**Department of Permitting Services
Fire Department Access and Water Supply Comments**

DATE: 09-Jan-25
TO: Patrick La Vay - plavay@mhgpa.com
Macris, Hendricks & Glascock
FROM: Marie LaBaw
RE: Bergfield Tract
120240130

RE: Preliminary Plan, Design Exception & TIS
Preliminary Plan No. 120240130
Bergfield Tract
Revised Letter

Re: **COMBINED STORMWATER MANAGEMENT
CONCEPT/SITE DEVELOPMENT
STORMWATER MANAGEMENT PLAN** for
Bergfield Tract
Preliminary Plan #: 120240130
SM File #: 292143
Tract Size/Zone: 9.72 AC.
Total Concept Area: 10.06 AC.
Lots/Block: NA
Parcel(s): Parcel P960
Watershed: ROCK CREEK / CLASS I
Redevelopment (Yes/No): YES

**FIRE APPARATUS ACCESS PLAN
PHASE 2**

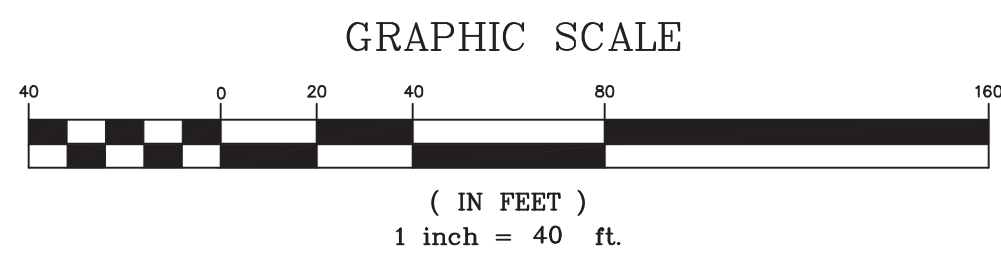
NOTE:
AN FDA AMENDMENT MUST BE SUBMITTED IN THE FUTURE FOR PHASE 2 WHEN FLOOR PLANS FOR SS-2 AND IF-2 BUILDINGS ARE AVAILABLE.
